Resolving D2.1 Comments 103, 182, 190

Tom Huber, Nokia Leon Bruckman, Huawei

Figure 155-5—Contents of OH fields in four-frame multi-frame

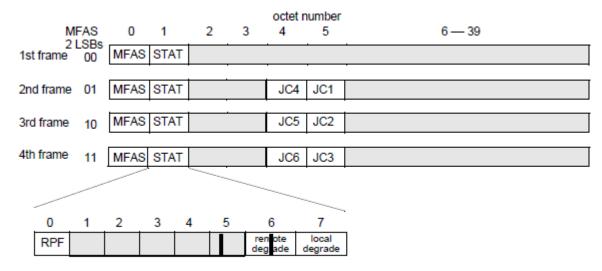
- #103 155.2.5.5.4, p47, line 30
 - Comment "The 400GBASE-ZR frame contains 1280-bit OH fields. This field is logically composed of inconsistent singular/plural
 - Suggested Remedy Replace: "The 400GBASE-ZR frame contains 1280-bit OH fields. This field is logically composed of" with: "The 400GBASE-ZR frame contains 1280-bit OH fields. These fields are logically composed of"
- #182 155.2.5.5.4, p47, line 30
 - Comment The first two sentences can be combined and made clearer
 - Suggested Remedy Rewrite as: The 128-bit OH field in the 400GBASE-ZR frame is logically composed of four 320-bit structures...
- #190 155.2.6.7, p53, line 15
 - Comment There is only one 1280-bit overhead field
 - Suggested Remedy Change "overhead fields" to "overhead field"
- While this appears to be a simple issue of singular vs. plural, it is more complicated, and concerns the structure of the 400GBASE-ZR frame

- 400GBASE-ZR uses only a small part of the overhead that ITU-T G.709.3 defines
- ITU-T G.709.3 defines the overhead based on the 100G frame (i.e., the 320-bit structure)
 - That frame itself uses a multi-frame because not all the overhead elements need to be present in every frame
- Figure 155-5 shows 4-frame multiframe that 400GBASE-ZR uses
- 155.2.5.5.[1-3] describe the 3 overhead elements (MFAS, STAT, JCn)
- 155.2.5.4 describes how this is encoded into the 1280-bit overhead area based on the four 320-bit structures

- Per Figure 155-4, there is a single 1280-bit field called "OH"
- Per clause 155.2.5.5, there are several "overhead fields" (MFAS, STAT, JCn) that are in specific locations within that 1280-bit field, as described on slides 4-5 of this presentation
 - Figure 155-5 is not a simple magnified of the 1280-bit OH field
- The underlying issue is ambiguity created by using "OH field(s)" to refer to both the 1280-bit field and to set of overhead elements/components (MFAS, STAT, JCn) within that field
- Proposal: use 'OH field' to refer to the 1280-bit field in Figure 155-4, and use 'overhead elements' or 'overhead components' to refer to the contents
 - This impacts text in 155.2.2, 155.2.5.5[.x], and 155.2.6.7[.x]
 - Give the editor license to make the appropriate changes in these subclauses
